ECQ method

(P802.3ds D1.2 comment 73, P802.3dj
D3.2 comment R2-205, and others)

Piers Dawe

P802.3dj D3.2 Comment R2-205

Figure 180–10—Illustration of the TDECQ measurement

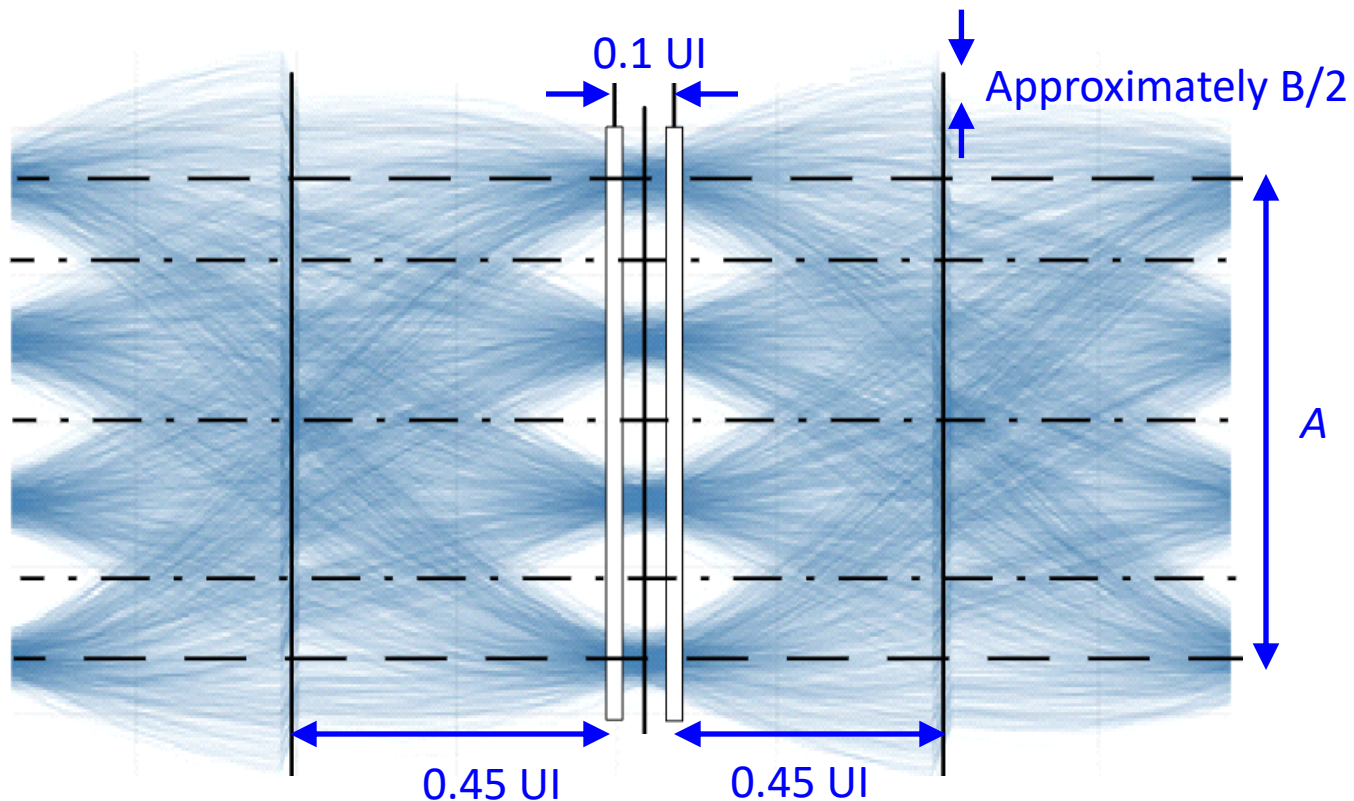
- If available, replace the graphic with one with the correct histogram window widths, transparent histogram windows, without the three vertical lines, and with the feedback transitions at 180° from the histograms
- No need to label the horizontal lines, which could be left out too

Figure 180–11—TDECQ reference equalizer functional model

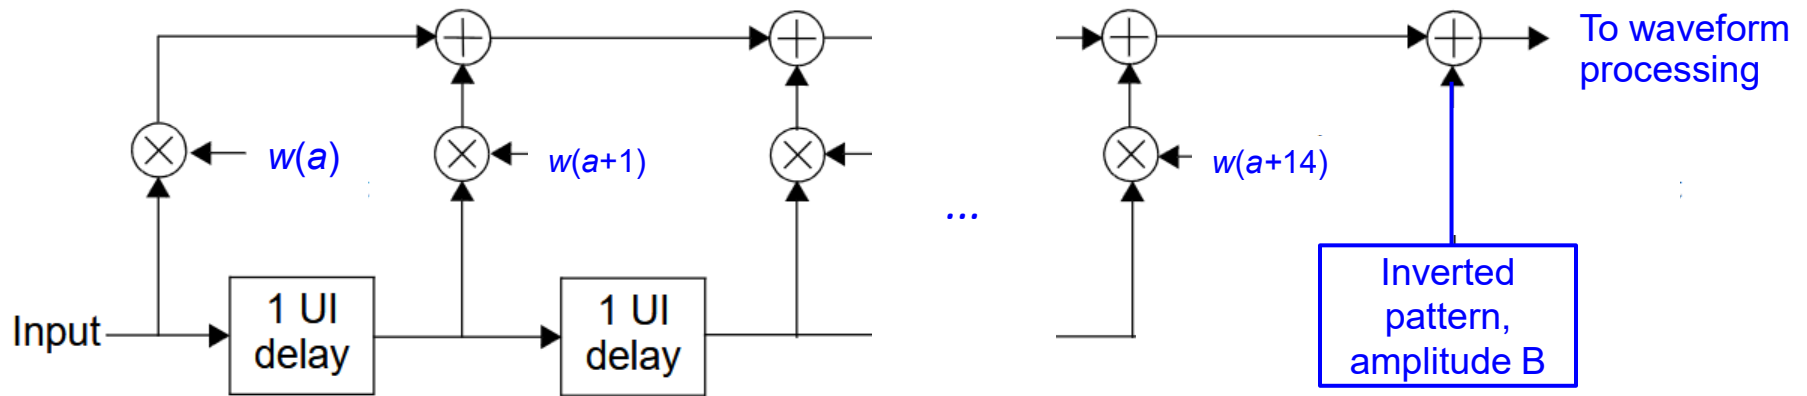
^{*} Following a question in the meeting: this should be B/A
